ADDENDUM NO. 01, dated June 21, 2023.

RE: BID 652, VENTURA COLLEGE CHILD DEVELOPMENT CENTER MODULAR – CLASSROOM & TWO SHADE STRUCTURES
AT
VENTURA COLLEGE
located at 4665 Telegraph Road, Ventura, CA 93003

- A. CHANGES TO BIDDING DOCUMENTS: None.
- B. CHANGES TO SPECIFICATIONS: None.
- C. CHANGES TO DRAWINGS: G0.00, A0.22, FP0.01 ADDITIONAL SHEETS: C3.0, C4.0

C3.00

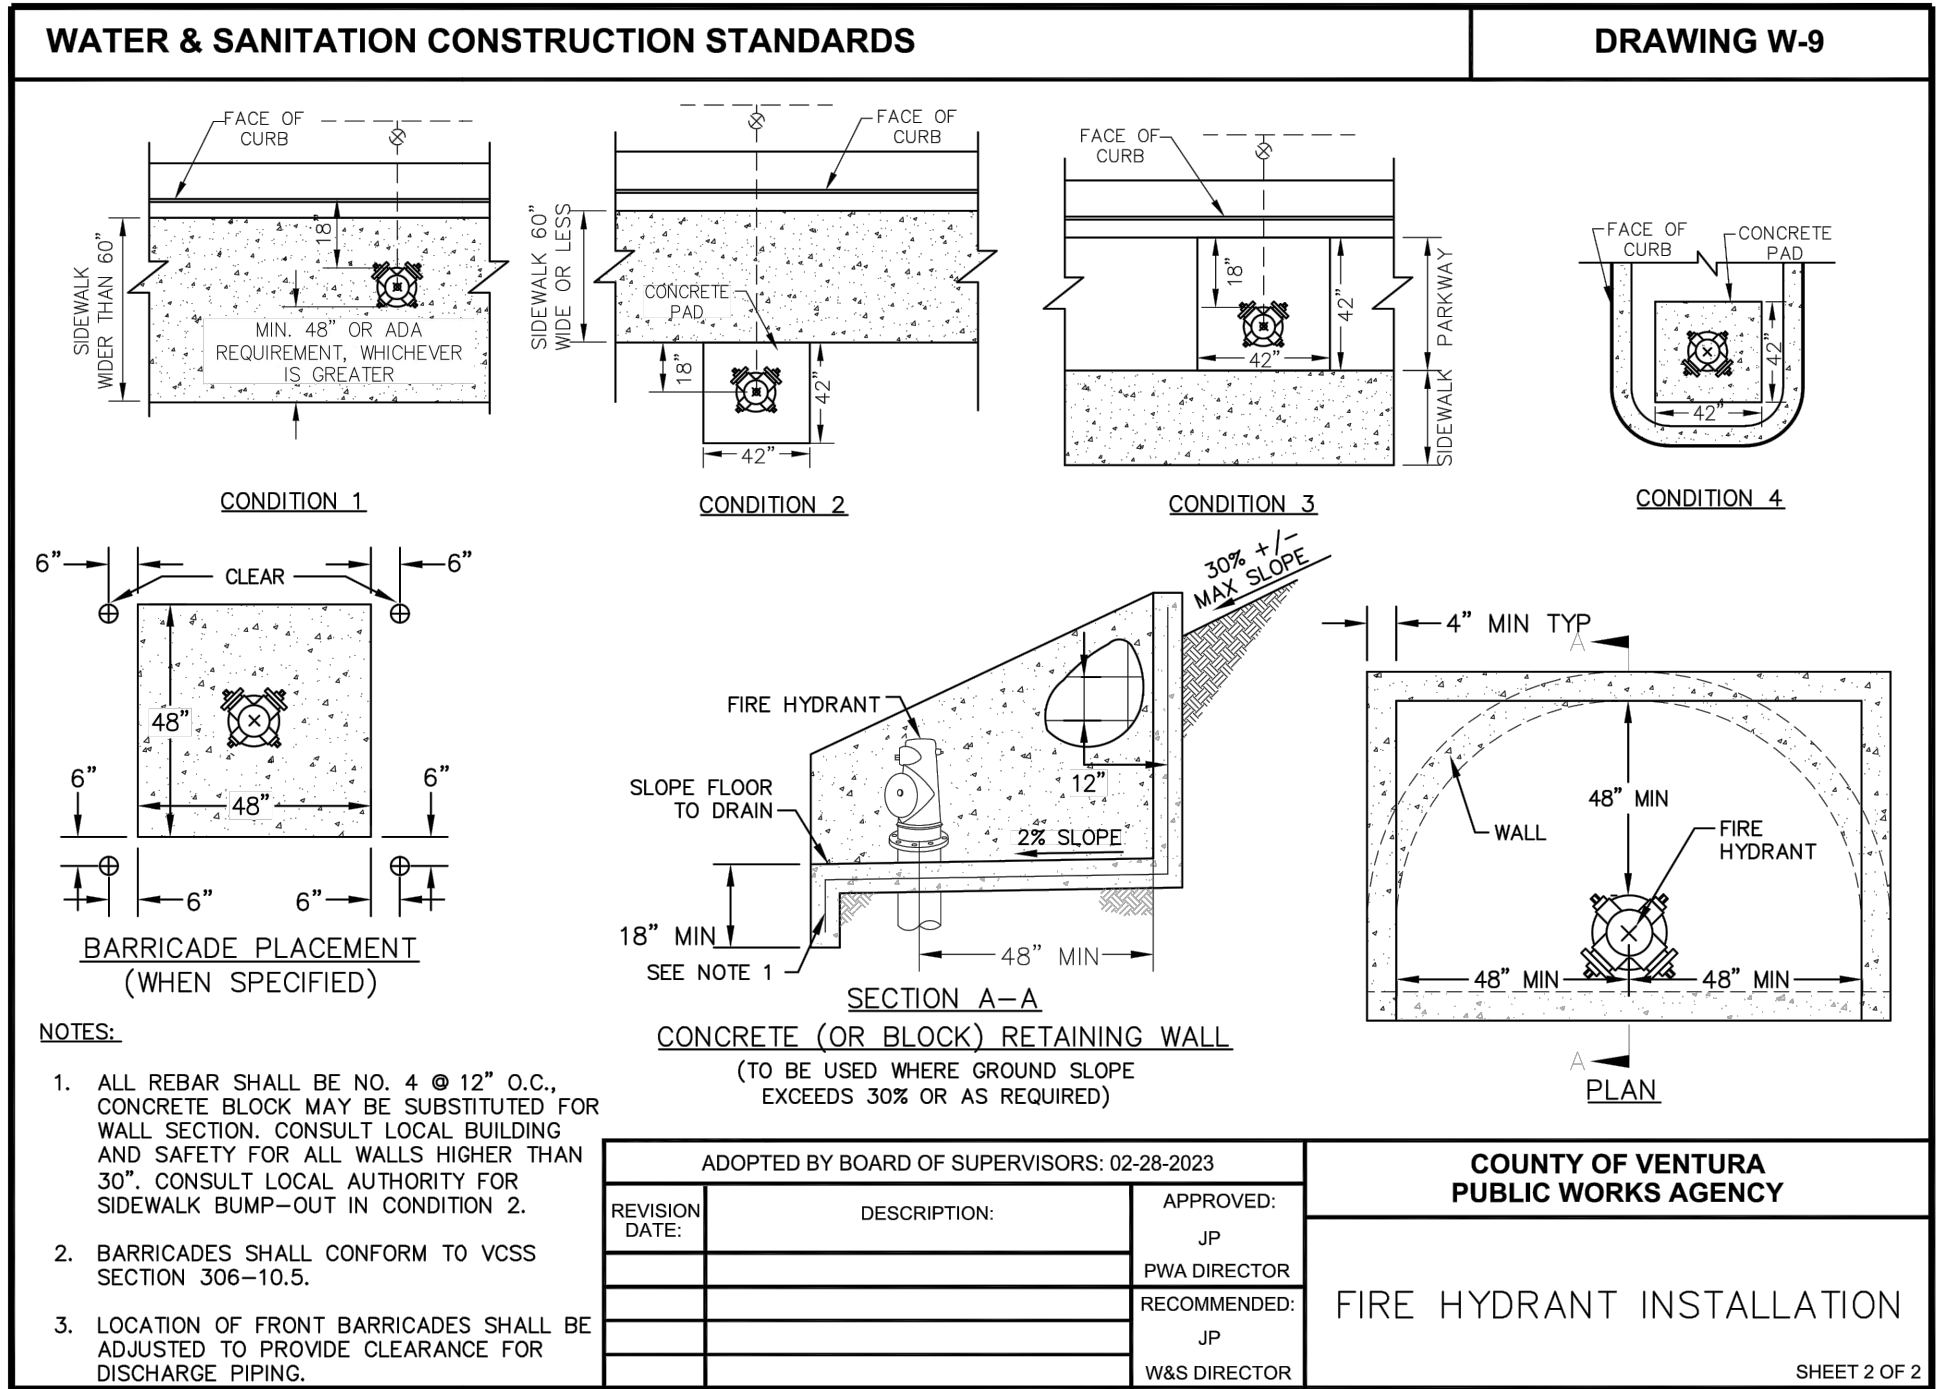
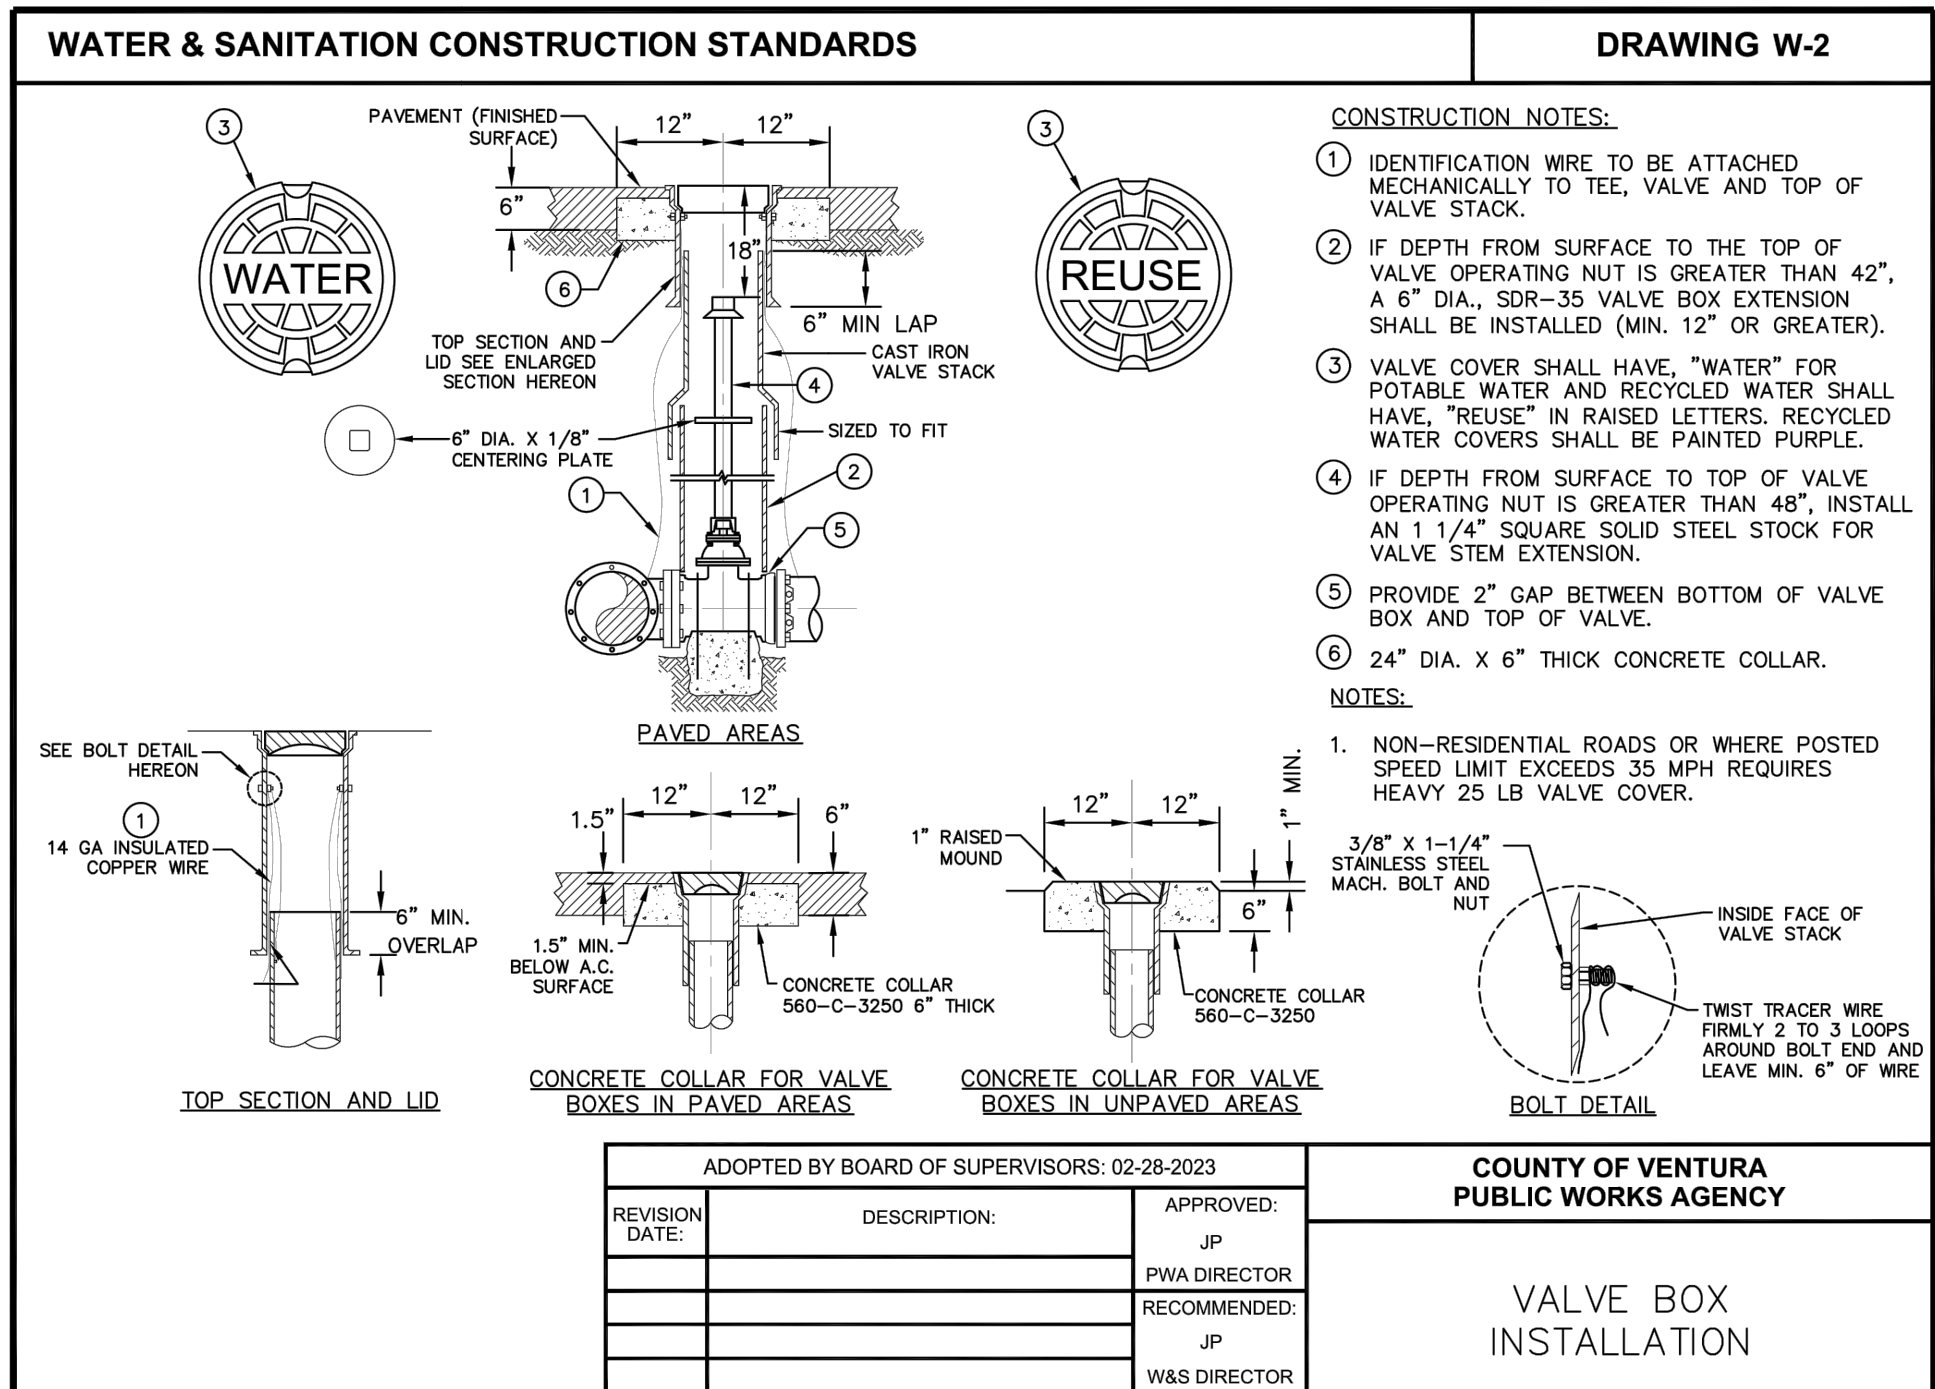
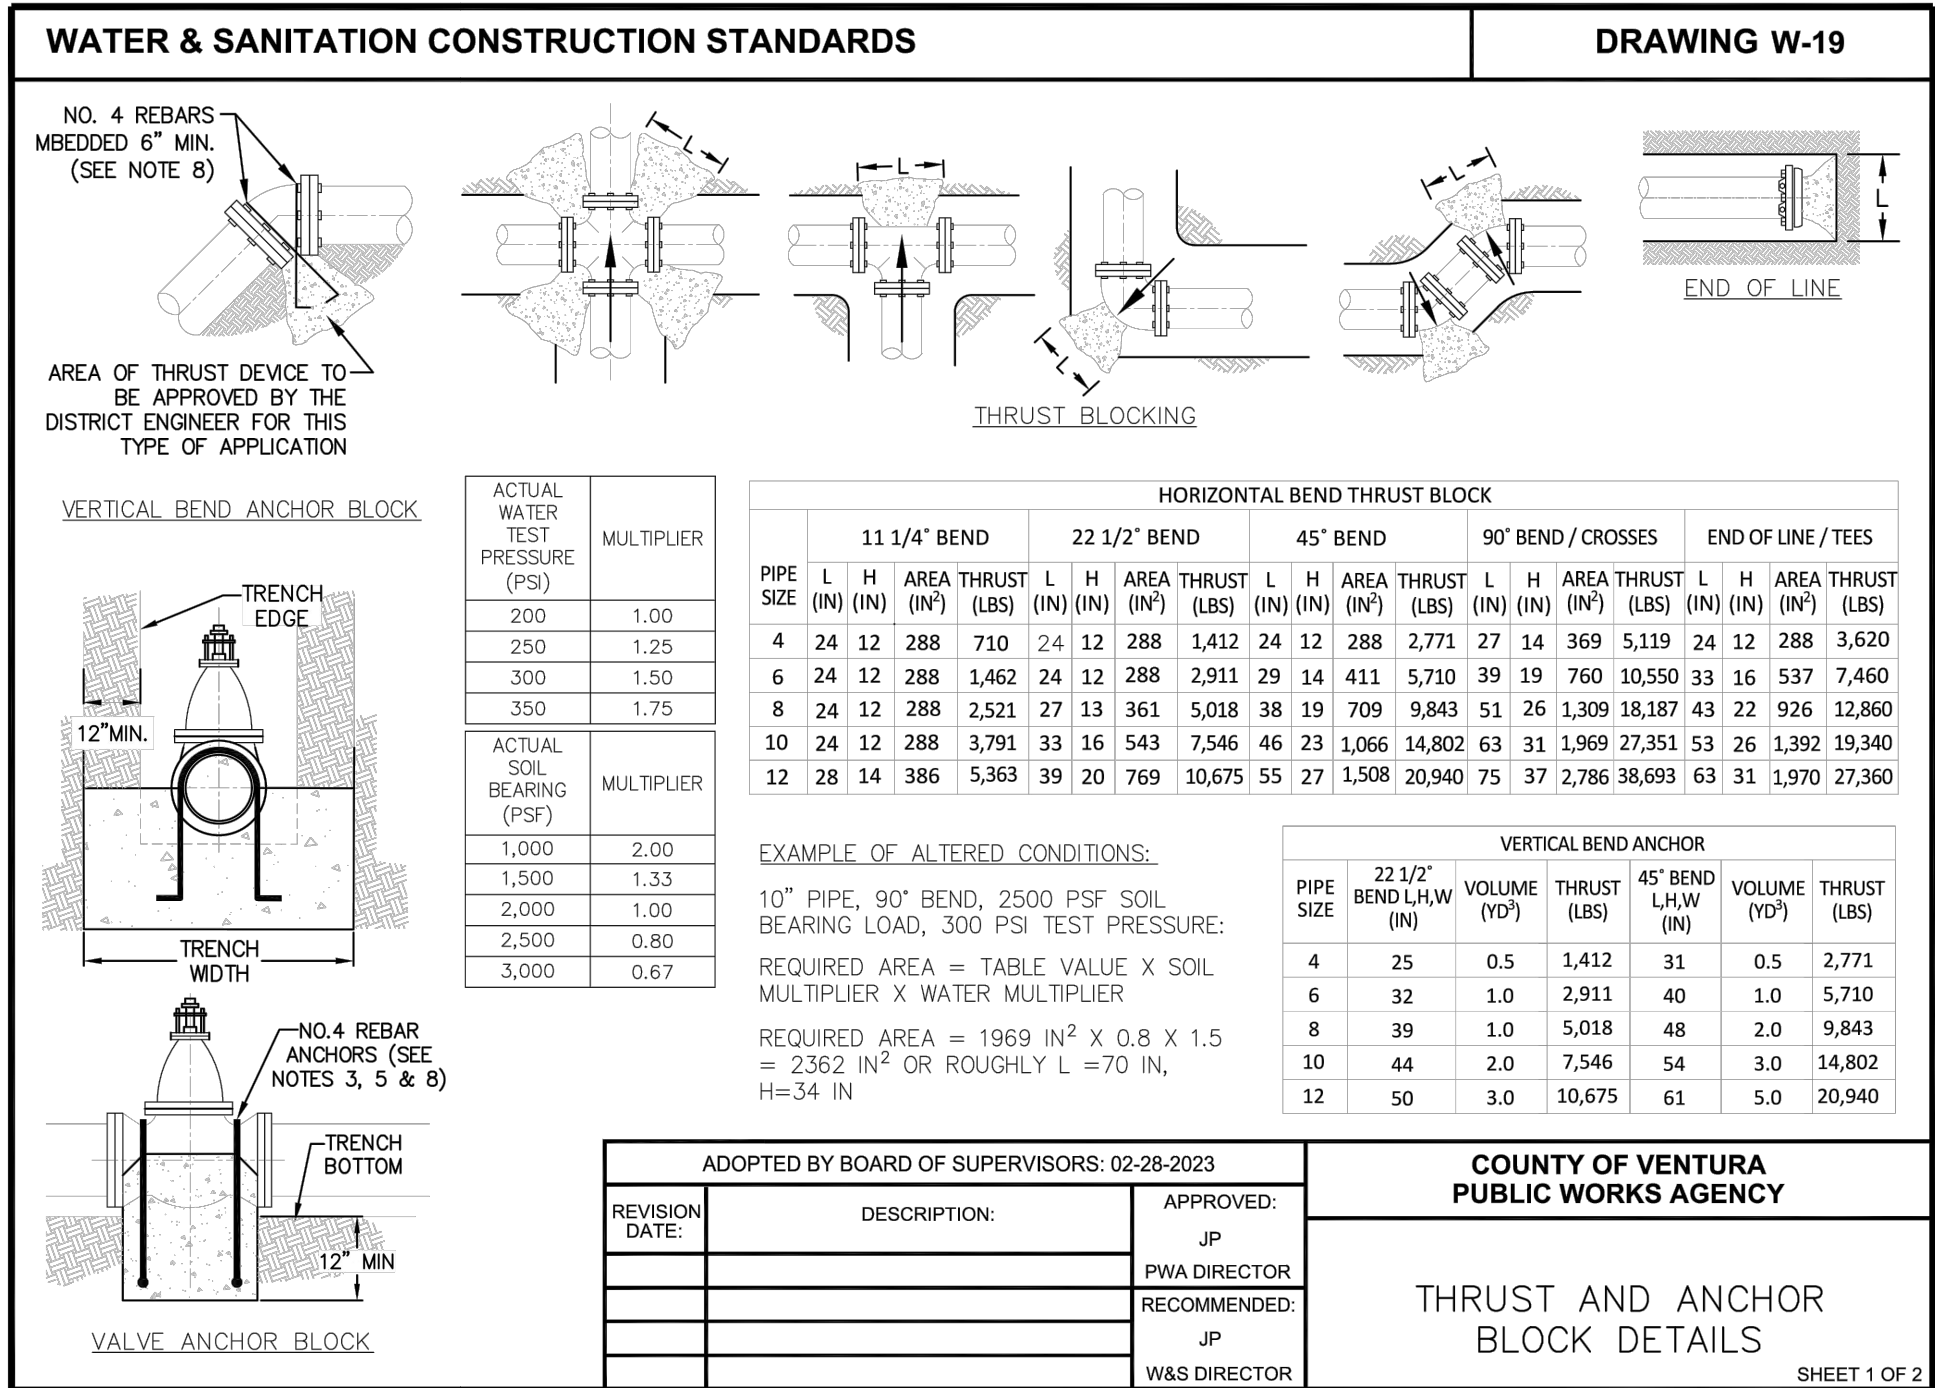
Answer: No
23. Who is going to install the fire hydrant?
Answer: The General Contractor
24. Who is going to install the TMP ramp for the new modular building?
